Model: AD1-E (Printer Controller)		Date: 30-Jun-97	No: 33
Subject: AD1-E Printer Controller Launching		Prepared by: A.Nakajima	
From: QAC 2nd Field Information Dept.			
Classification:	<input type="checkbox"/> Troubleshooting	<input type="checkbox"/> Part information	<input type="checkbox"/> Action required
	<input type="checkbox"/> Mechanical	<input type="checkbox"/> Electrical	<input type="checkbox"/> Service manual revision
	<input type="checkbox"/> Paper path	<input type="checkbox"/> Transmit/receive	<input type="checkbox"/> Retrofit information
	<input checked="" type="checkbox"/> Other (Launching Information)

Model: AD1-Printer Type 250		Date: 23-Jul-97	No: 35B
Subject: Firmware and Software History		Prepared by: K.Ugaeri	
From: QAC Field Information Dept.			
Classification:	<input type="checkbox"/> Troubleshooting <input type="checkbox"/> Part information <input type="checkbox"/> Action required <input type="checkbox"/> Mechanical <input type="checkbox"/> Electrical <input type="checkbox"/> Service manual revision <input type="checkbox"/> Paper path <input type="checkbox"/> Transmit/receive <input checked="" type="checkbox"/> Retrofit information <input type="checkbox"/> Ot

\*Kit number : A6439900 HDD Bracket Kit

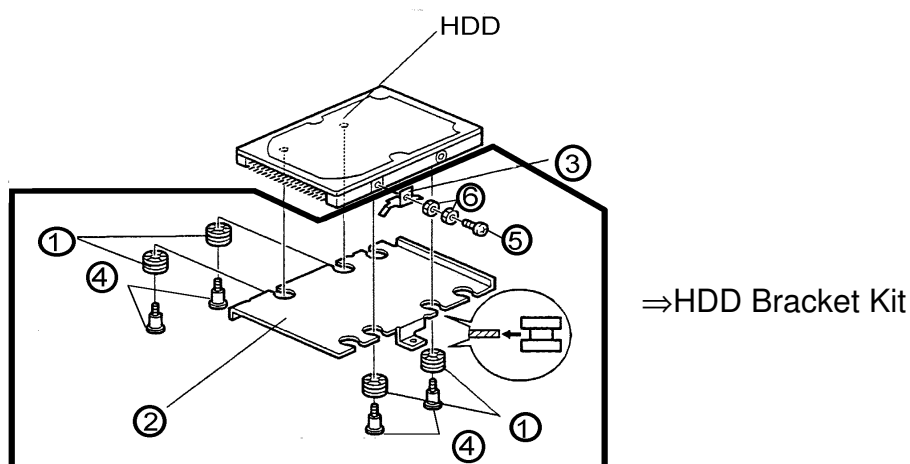
The HDD bracket has been modified for the print-overflow problem caused by vibration from the duplex unit (refer to RTB37). These new brackets have been available from June production in 1997 (the cut-in serial number is A7327060001-)

If you have the print overrun problem on an AD1 with a duplex unit or when you visit a customer whose machine has the old HDD bracket, please change the bracket to a new type.

① AA161125 Bushing – HDD	4 pcs
② A1935840 HDD Bracket	1 pc
③ A1935842 Grounding plate – HDD	1 pc
④ A1935843 Stepped Screw	4 pcs
⑤ 03130050B Philips Pan Head Screw - M3x5	1 pc
⑥ 07120030W Nut -M3	2 pcs
A6438612 Instruction Guide	1 sheet
